# Viaducts, Eastern Core and False Creek Flats Cycling Improvements

HUB Vancouver/UBC committee

2013/05/13

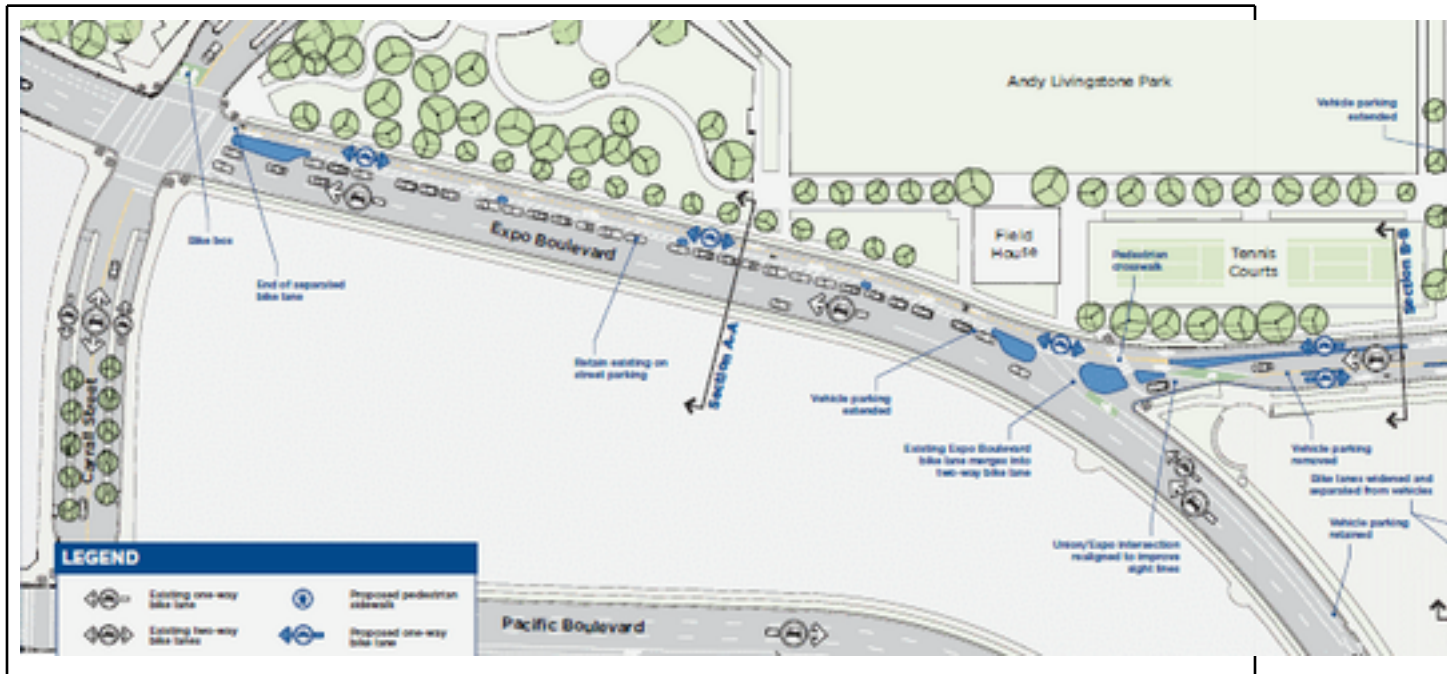
- Make extra space to accommodate two-way bike lane on the north side of Expo Boulevard Between Quebec and Abbott.
- Add a new separated bike lane on Expo Boulevard between Abbott to Cambie by BC Place.
- Add a new separated bike lane from Abbott to Carrall under the proposed Cycling Bridge.
- Relocate the proposed bicycle and pedestrian paths along New Street under the SkyTrain guideway.
- Add a new cycle lane on Taylor Street and add cycle paths from Keefer Street to Expo Boulevard.
- Add a new two-way separated bike lane on New Street between Carrall and Cambie.

HUB's proposals are shown in the following map, which is based on the City's "New Concept Cycling Network" shown previously. Opinions differ within HUB Vancouver about how far east the Cycling Bridge and its southern fork should extend. The map shows the Cycling Bridge extending as far east as Quebec, whereas some in HUB propose that the Bridge extend just a little east of Carrall Street. The map also shows the southern fork extending almost to Quebec whereas some in HUB suggest the southern fork extend down to either just west or east of Carrall.

### **New Cycle Lane on Taylor Street, Cycle Paths from Keefer Street to Expo Boulevard**

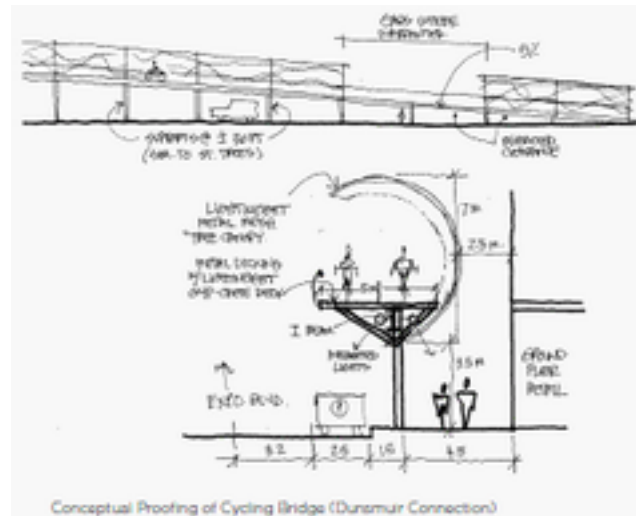
Cycle lanes should be added on Taylor Street from Pender Street to Keefer Street and cycle paths should be added from Keefer Street to Expo Boulevard. Currently, people cycle through Andy Livingstone Park from Pender Street and Taylor Street (and sometimes through the playground) to the corner of Pacific Boulevard and Carrall Street. A school is planned for this corner, so a cycle path would be useful for future students. There should be a good connection to Carrall Street from where this path meets Expo Boulevard.

### **Weather Protection at Western End of Cycling Bridge**

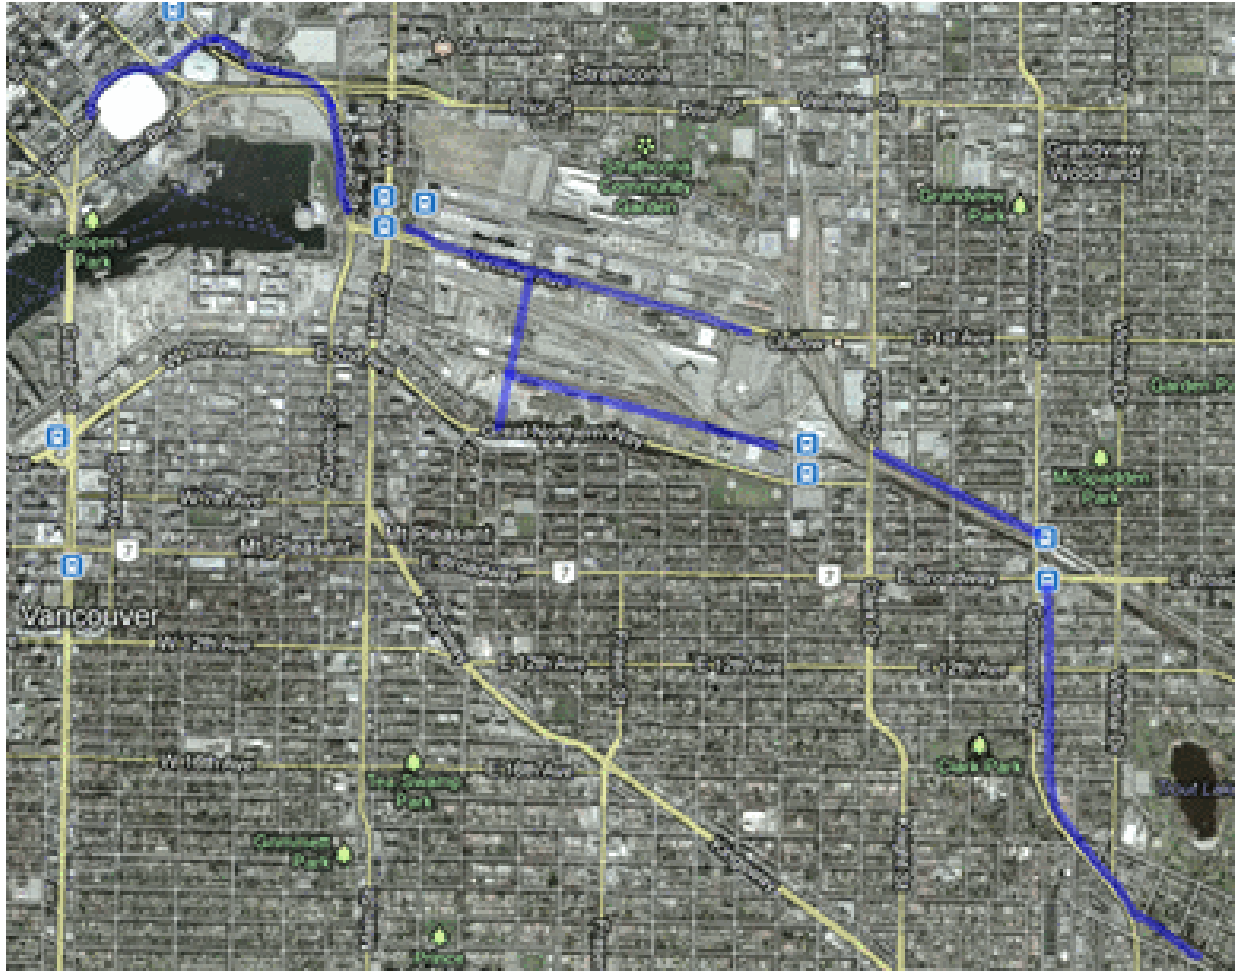
In line with the weather protection offered by the SkyTrain guideway, the screen proposed for the Cycling Bridge could be changed to a weatherproof material. This would also help prevent ice from forming in some conditions, making it safer.
